STAFF RECOMMENDATION

NCPC File No. 6479

SMITHSONIAN INSTITUTION
PATENT OFFICE BUILDING
COURTYARD LANDSCAPE
G, F, 7th, and 9th Streets, NW

March 30, 2006

Layout - one historical fountain

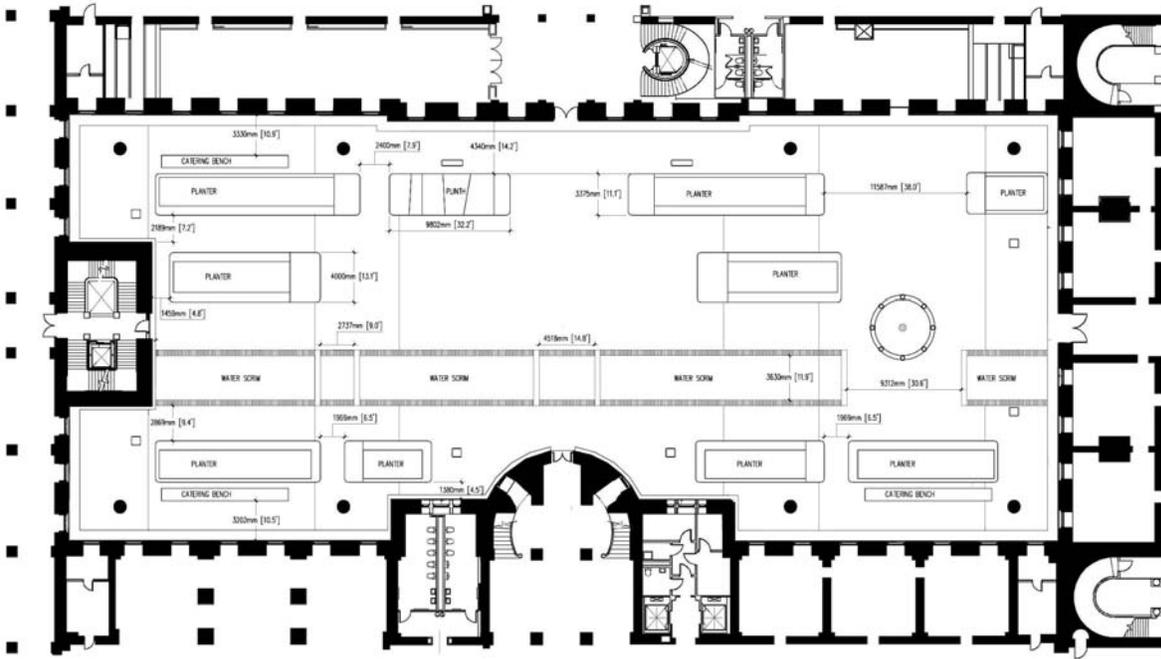
One of the historic cast iron fountains is included in an alternate landscape plan. The physical condition of the fountains is described earlier in this report. The Smithsonian's designer does not favor a landscape scheme that includes the fountains. Given the signature style of the landscape architect selected by the Smithsonian, the staff concurs that the historic fountain is an awkward element in the alternate composition as presented and finds that it has not been well integrated with the new elements to be introduced to the courtyard.

Secretary Small committed in writing in June 2005 to repair to working order and reinstall the fountains. The reinstallation of the fountains was partial mitigation of the courtyard enclosure and a condition for its approval by the Commission at its September 2005 meeting.

Concurs with the Smithsonian that the historic courtyard fountains are in fair to poor condition, that they will not be restored and reinstalled to working order either in the courtyard or in the lawn as Secretary Small committed to doing in June 2005, and that, in partial mitigation for the loss of the historic courtyard, they instead be treated as artifacts and interpreted in the permanent exhibit on the history of the building in a gallery inside the F Street entrance.

Requires that, prior to final submission of the courtyard landscape, the Smithsonian develop a plan for the introduction and interpretation of the historic fountains in the museum exhibit and related publications.

Elements - catering benches

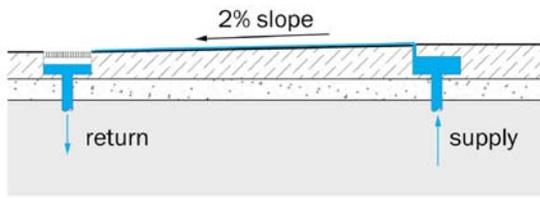
The catering functions and locations have still not been resolved satisfactorily, although the staff appreciates the Smithsonian's continuing efforts in this regard. The Smithsonian made an early decision to accommodate the catering function and storage completely in the courtyard (considered more as an event space) rather than in the building itself. With the subsequent attention of the Commission and other review agencies to the necessity of restoring the courtyard as a public amenity for all visitors, with landscape characteristics more similar to those of the historic courtyard, the Smithsonian's early programming decision has become problematic.

The Smithsonian has submitted several iterations of catering structures to the Commission in the past two years. The three "catering benches"—long, bar-height stainless steel boxes when closed and not in use and taller warming and plating stations when open and in use—are an improvement on the original concept, but they are still significant elements inserted in the courtyard landscape. They are almost as long as the planters and are placed 1.6 feet away from the edges of the planters—too close for easy circulation and for comfortable spacing in a courtyard of this size. Aside from concerns about the attractiveness of their appearance and function when raised open and in use for evening functions, they have very limited utility as courtyard elements during the day when the museum is open to public visitors. It is unfortunate that they will detract from the new courtyard setting and ambience that the Smithsonian and the Commission seek to achieve. As functional objects, they are awkwardly located, affect circulation, eliminate the ability to design seating areas for the planters against which they are placed, detract from the nearby plant materials, and are too visible to be compatible with the character and setting of the courtyard. *The staff recommends that the catering benches as designed and located in the current submission be disapproved, and recommends that the primary catering utilities and storage be removed from the courtyard.*

Disapproves the catering benches as designed and located, and recommends that the primary catering utilities and storage be removed from the courtyard.

Section at water scrim

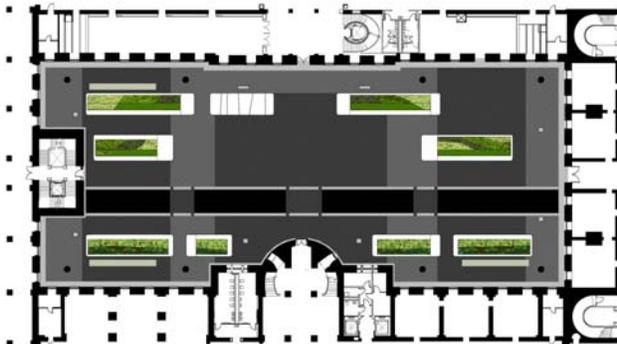
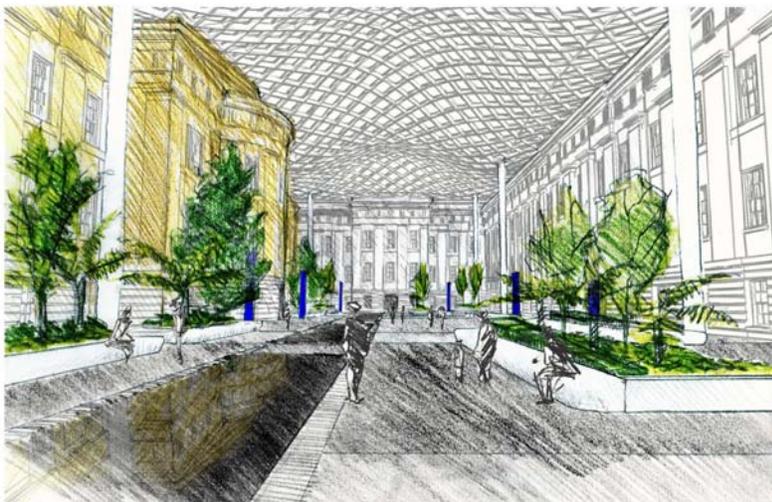
The water scrim is a good solution because it does not add weight to the floor and allows children (and adults) to experience the water without splashing. It will become a popular feature of the courtyard. But it is a dominant feature and extends wall to wall, which divides the space awkwardly when the scrim is turned on. The pedestrian path is door to door through the courtyard (primarily north-south, but also east-west). The water scrim is off-axis, as it needs to be to accommodate pedestrian circulation. However, as a result, its off-axis location is emphasized by the boldness of its wall-to-wall length, which is a contemporary conception and not compatible with the historic facades or spatial character of the courtyard. As the water scrim has been developed since concept, the Smithsonian has divided it into four sections, with greater emphasis on the north-south paths and on the tri-partite composition of the courtyard floor. In comparing the Patent Office courtyard with the one at the Seattle Opera, one obvious difference is that the Seattle building's lobby is contemporary in its spatial proportions and has great transparency, so the scrim is entirely compatible in that context since it seems to extend into infinity.

The staff recommends that the extent and proportion of the scrim in relation to the Patent Office Building courtyard facades and plan needs further study as it is developed further. Perhaps its strong linearity would be relieved by not extending the scrim all the way to the east and west facades. The staff also suggests that removing the metal grates in the north-south paths (where water is not designed to flow) would also allow this proposed element to be more complementary of the courtyard facades and proportions. *The Executive Director's Recommendation directs the Smithsonian to restudy the design of the water scrim to be more responsive to the "design character and setting" of the courtyard as a central gathering space, softening the scrim's dominant linearity across the courtyard floor in order to improve its compatibility with the courtyard facades and spatial proportions.*

Recommends that the water scrim be redesigned to be more responsive to the “design character and setting” of the courtyard as a central gathering space, softening the scrim’s dominant linearity across the courtyard floor in order to improve its compatibility with the courtyard facades and spatial proportions.
